WATER PERMIT NO. 8890-3

SOUTH DAKOTA
WATER PERMIT NO. 8890-3

Renewal of water right for the New Stickney dam in Aurora County that failed in 2019.

RE: Water Permit Application No. 8890-3

Figure 2: Plot of total runoff for the watershed above the proposed dam against probability of exceedance (note percent in Table 1 have been converted to decimal). Note this plot and trendline is only applicable for this specific watershed location and area.

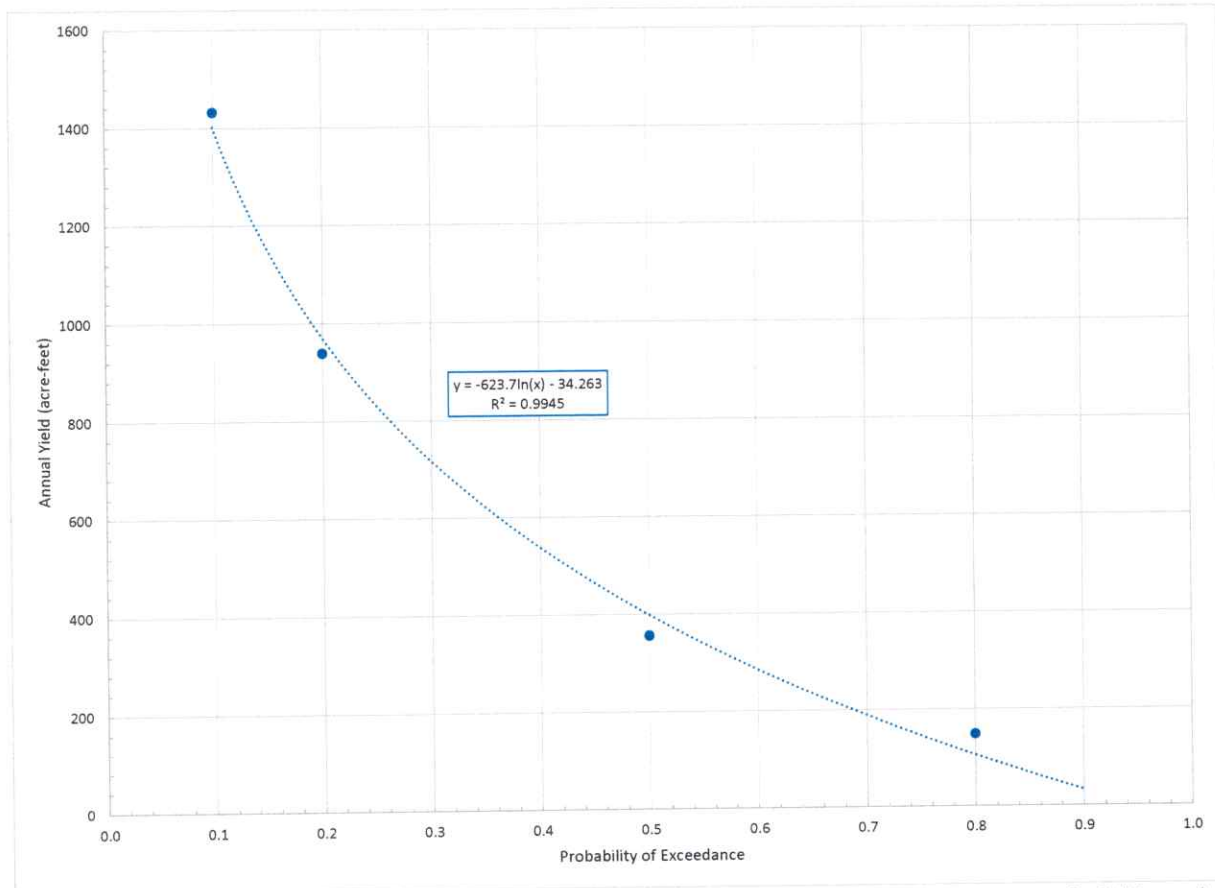
To estimate the percent chance of occurrence of enough annual runoff to provide a full fill of the reservoir to the elevation of the primary spillway (normal storage, 83 acre-feet), the total runoff from Table 1 was plotted against probability of exceedance (showing in Figure 2) The plotted data

shows a very good correlation (the closer a r square value is to 1 the better the fit or correlation of the trendline to the data points) to a logarithmic trendline (shown on Figure 2). Solving the trendline for a volume of 83 acre-feet results in an estimated percent chance of annual exceedance of 83 percent to go from dry to full normal storage. Typically, a lesser amount of runoff will be needed since the dam will not be starting from a dry condition each year.

The annual surface runoff yield estimates indicate there is a high probability of sufficient runoff occurring to support the request of this application. Only in extremely dry years, or extreme dry multiyear periods, would water availability be expected to be insufficient to provide the reservoir with a fill to normal pool.

Figure 3: Existing and proposed primary spillway and auxiliary spillway design curves (Houston Engineering, Inc., 2023). Note there is no combine rating curve, so discharge for the principal (primary) and auxiliary spillways must be added to get total discharge at a given elevation.

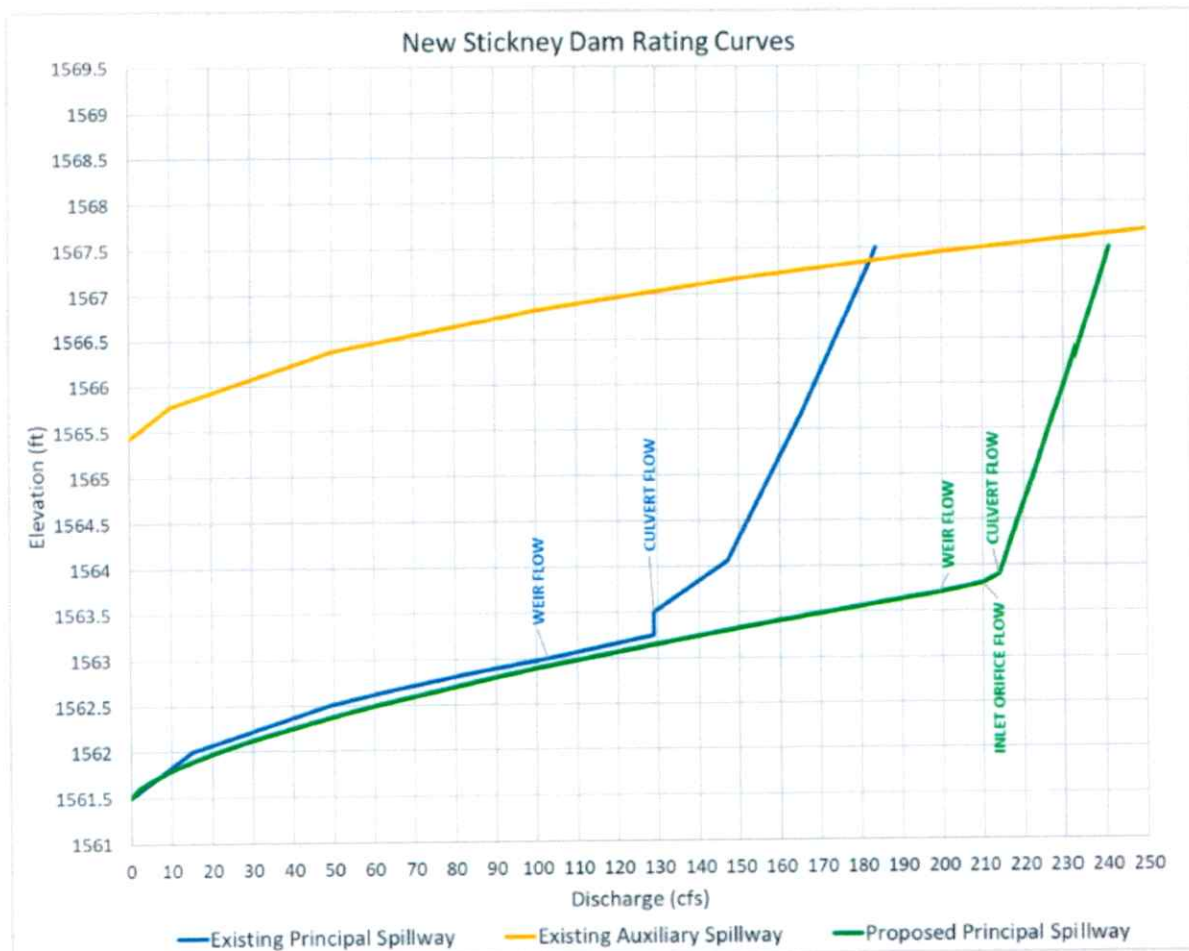
Since this is a category 3 dam that has failed and is being reconstructed, the reconstructed dam must comply with the minimum spillway requirements of ARSD 74:02:08:07. Pursuant to

ARSD 74:02:08:07 and ARSD 74:02:08:07.1, this dam must have the hydraulic capacity to pass at minimum a design flood of a 25-year, 24-hour storm unless the owner can provide information and justification to show that the design flow can be stored, passed through, or passed over the dam without failure of the dam. Houston Engineering, Inc. (2023) used HEC-HMS modeling to estimate a peak inflow into the reservoir of 346.6 cubic feet per second (cfs) during the 25-year, 24-hour storm using a rainfall of 4.25 inches from the National Oceanic and Atmospheric Administration's (NOAA) Atlas 14. The runoff information from Houston Engineering, Inc. (2023) was accepted since the watershed was delineated using LiDAR derived elevation data and HEC-HMS modeling tends to be more watershed specific and detailed than the more generalized estimate from USGS Streamstats. Houston Engineering, Inc. (2023) provided the spillway rating curves for the existing and reconstructed primary spillway designs shown in Figure 3. Figure 3 indicates that between the primary and auxiliary earthen spillway the reconstructed dam is expected to have sufficient spillway capacity to meet minimum South Dakota design standards.
